# Access Compliance Report

## Public Rights-of-Way

Intersection ID: 47457	Main Street: STEELE_CREEK_RD	Cross Street: WINGED_TEAL_RD	Location: SE
ADA ID: C298CE873CB0	Ramp Type: Perp	Initial Pass/Fail: Fail	Overall Compliance: No
Severity Score: 46.25			
Codes/Mitigation Info/Possible Solution		Field Measurements/Component Compliance

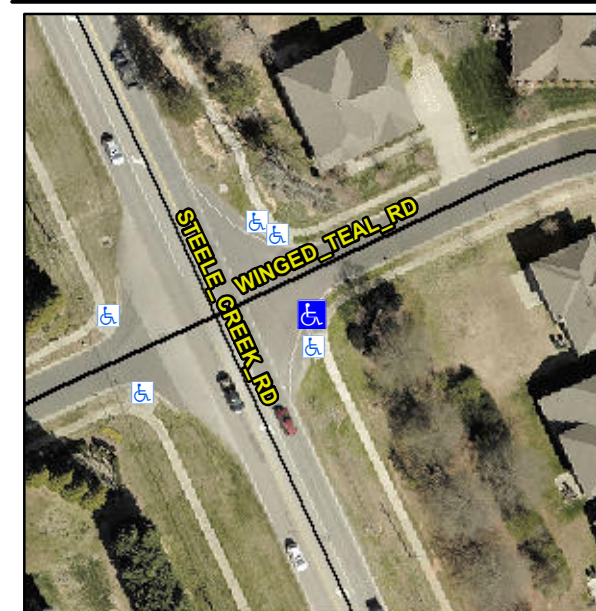
**R304.5.1, R304.2.2, R304.5.3**

Compliance	Description	Data	Compliance	Description	Data
N/A	Ramp Length (in)	54.0	No	Ramp Slope (%)	8.4
No	Ramp Width (in)	47.0	No	Ramp XSlope (%)	8.1
N/A	Flare Type LT	N/A	N/A	Flare Type RT	N/A
N/A	Flare Slope LT (%)	N/A	N/A	Flare Slope RT (%)	N/A
N/A	Flare Traversable LT?	N/A	N/A	Flare Traversable RT?	N/A
N/A	Landing Length (in)	N/A	N/A	DWS Provided?	N/A
N/A	Landing Width (in)	N/A	N/A	DWS Contrast?	N/A
N/A	Landing Slope (%)	N/A	N/A	DWS Length (in)	N/A
N/A	Landing X Slope (%)	N/A	N/A	DWS Full Width?	N/A
N/A	Landing Curb? (Y/N)	N/A	N/A	DWS Offset (in)	N/A
N/A	Shared Landing?	N/A			
N/A	Gutter Ponding?	N/A	N/A	Gutter Slope (%)	N/A
N/A	Gutter Lip Ht (in)	N/A	N/A	Gutter X Slope (%)	N/A
N/A	Painted X Walk1?	No	N/A	Painted X Walk2?	N/A
	X Walk 1 Direction	To N		X Walk 2 Direction	N/A
N/A	X Walk 1 Width (in)	N/A	N/A	X Walk 2 Width (in)	N/A
	X Walk 1 Slope (%)	4.2		X Walk 2 Slope (%)	N/A
	X Walk 1 X Slope (%)	3.9		X Walk 2 X Slope (%)	N/A

**Remove & Replace Entire Ramp.**
